**STAFF RECOMMENDATION**

**116 3<sup>rd</sup> Avenue South**

**February 17, 2021**

**Application:** Rehabilitation; Signage

# ELEVATIONS

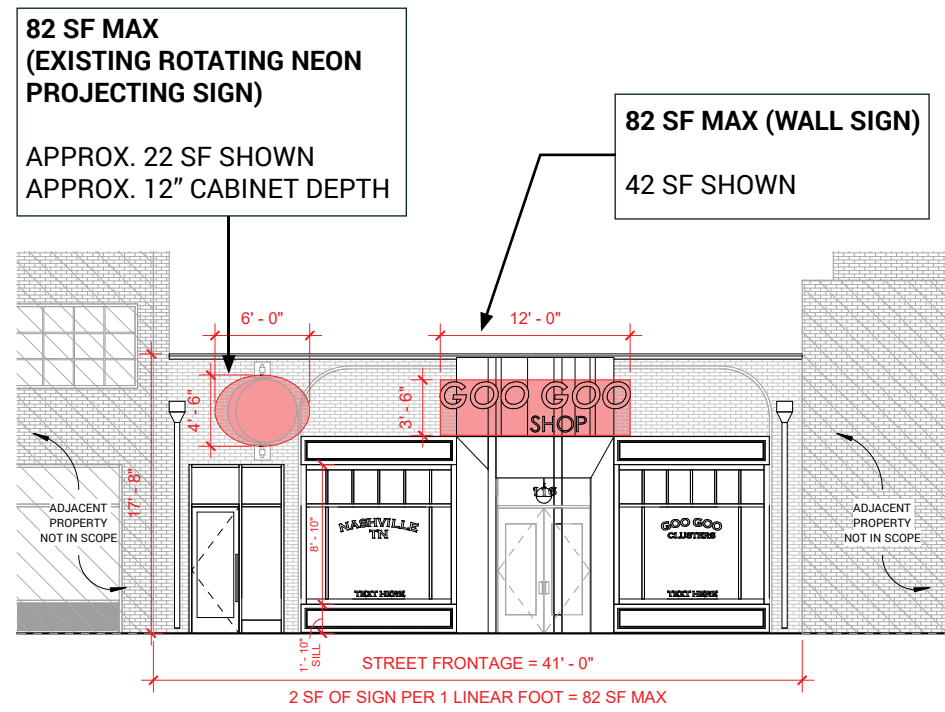
Storefronts, Doors and Entryways: The left bay currently has a modern storefront entrance with an aluminum door, sidelight, and transom. This storefront entrance will be replaced with a new storefront, matching the existing configuration with a dark colored aluminum frame. Staff finds that the contemporary storefront entrance in the left bay is appropriate for the style and period of a non-contributing building. Staff asks to approve the metal and glass color, and the mullion profile of the entrance prior to construction.

Although the building has four bays, the remaining three bays appear and function as a three-bay storefront. The center bay contains a doorway inside a shallow vestibule. The existing doors are to be replaced with a pair of new doors. The doors will be wood with a full-light center panel, which are appropriate for the style and period of a non-contributing building.

A new door surround will be added on the sides of the entrance, from the ground to the top of the building's parapet. The surround will be wood or cement-fiberboard. While door surrounds are typical of entrances on historic buildings, the proportions of the current proposal are exaggerated compared to historic examples. However, because the building is not historic, staff finds the proposed door surround to be compatible with the style and period of the building. The existing transom inside the vestibule will remain unaltered.

Display Windows, Bulkheads: The remaining two bays contain large window openings, with modern aluminum windows that have a multi-light appearance similar to industrial windows, which sit atop a rowlock brick sill.

These windows will be replaced with new storefront windows with paneled bulkheads above and below. The width and header height will not change, but the sill will be lowered to one foot, ten inches (1'-10"). The opening size is compatible with the openings of historic buildings. The new windows will be aluminum storefront type with a large center pane with muntins dividing smaller panes on the sides and across the top.

A new paneled bulkhead will be added above and below the new display windows. Bulkheads and transoms are typical of buildings in the overlay, and the proposed bulkheads read as a contemporary adaptation of these types of features. Staff finds the panels to be compatible with the style and period of this non-contributing building.

Windows: The windows on the rear of the building will be replaced with new aluminum storefront windows, with a pair of single windows replaced with a set of three windows. The new windows and new window pattern on the rear of the building is compatible with the style and period of this non-contributing building.

Paint: Prior to being included in the overlay, the building was painted taupe and then painted its current off-white color in 2014, just before the overlay was extended to include this building. In the current proposal, portions of the masonry façade would be painted blue.

The proposal to paint portions of the front brick wall blue does not meet section II.M. of the design guidelines. Staff recommends that the masonry color remain as-is or be a historic red brick color.

Lighting: The proposal includes a contemporary pendant light and recessed lighting in the vestibule of the third bay from the left. Staff finds that the recessed lighting in the side panels of the door surround meet the design guidelines, which say that exterior lighting should be concealed, simple, and unobtrusive. Although a contemporary fixture may be appropriate for the style and period of the building, staff finds that a pendant light is not concealed or unobtrusive. A similar fixture, mounted higher or flush-mounted on the ceiling of the vestibule, would be appropriate.

1. Masonry selections (brick, stone, and mortar) for the rear wall are approved administratively;
2. The metal and glass color, and the mullion profile of the storefront doors and windows are approved administratively prior to construction.
3. The painted masonry remain as-is, or be repainted a color matching the original brick color as currently seen on the rear wall;
4. The rear painted signage is an appropriate type of paint; and
5. The lighting fixture in the vestibule is concealed.

### SIGNAGE DETAILS

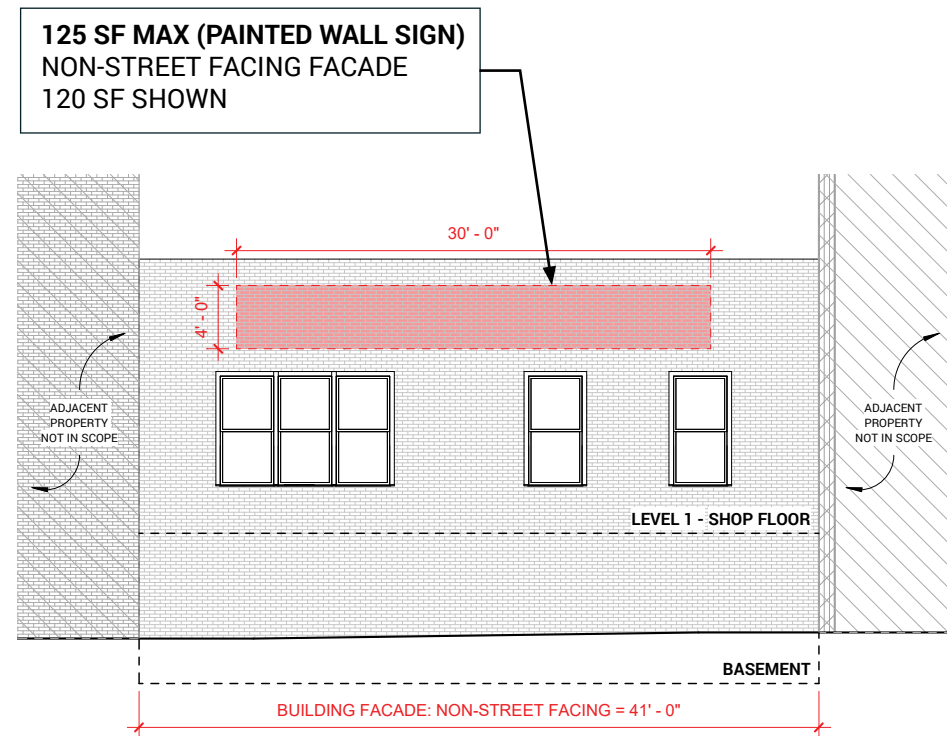
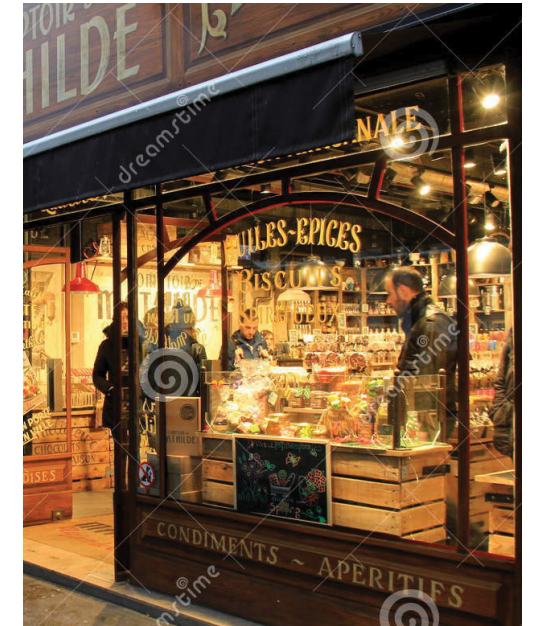
Signage: The proposal includes a new wall sign over the doorway in the third bay from the left. An existing projecting sign above the entrance on the left bay will remain.

The guidelines permit up to two square feet (2 sq. ft.) of signage per linear foot of primary building façade. This building has forty-one feet (41’) wide, therefore the allotment of building signage on the primary façade is eighty-two square feet (82’ sq. ft.).

Existing Projecting Sign	= 16 square feet
Proposed Wall Sign	= 42 square feet
Total	= 58 square feet

The building sign above the door will be backlit letters on the upper section of the new door surround. This type of sign and the proposed location are appropriate.

The proposal includes a painted signage to be painted on the rear wall after it is rebuilt.

The guidelines allow painted signs on rear facades, not to exceed one hundred and twenty-five square feet (125 sq. ft). The area of the proposed rear wall sign is one hundred, twenty square feet (120 sq. ft.).

With a condition that the rear wall signage is in an appropriate type of paint, Staff finds that the proposed signage on the rear of the building meets Section IV.B of the design guidelines.
